ECE/TRANS/WP.29/GRRF/2009/23/Rev.2
30 June 2010

Regulation No. 90
(Replacement brake linings)

Proposal for amendments to Regulation No. 90

Submitted by the expert from Germany */

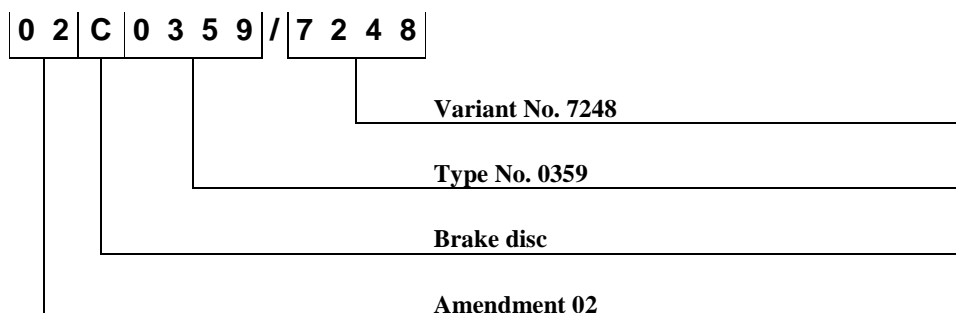
"4.2. To each **replacement part** approved there shall be assigned an approval number comprising four groups of digits:

4.2.1. The first two digits (at present **02** for the Regulation in its **02** series of amendments) shall indicate the series of amendments incorporating the most recent major technical amendments made to the Regulation at the time of issue of the approval.

4.2.2. **The following single digit shall indicate the category of the replacement part as follows:**

4.2.3. **The next four digits shall indicate the manufacture and the type of the brake lining, the type of disc or the type of drum.**

A suffix of four digits shall indicate

- (a) the shoe or back plate or specific dimension in the case of drum brake linings**
- (b) the variant in the case of a replacement disc or replacement drum**

4 digits indicate the variant / shoe / back plate / specific dimension of the replacement part (0001 to 9999)

4 digits indicate (manufacturer and) the type of the replacement part (0001 to 9999)

1 digit (A to D) indicates the category of the replacement part

2 digits indicate series of amendment (01 to 99)
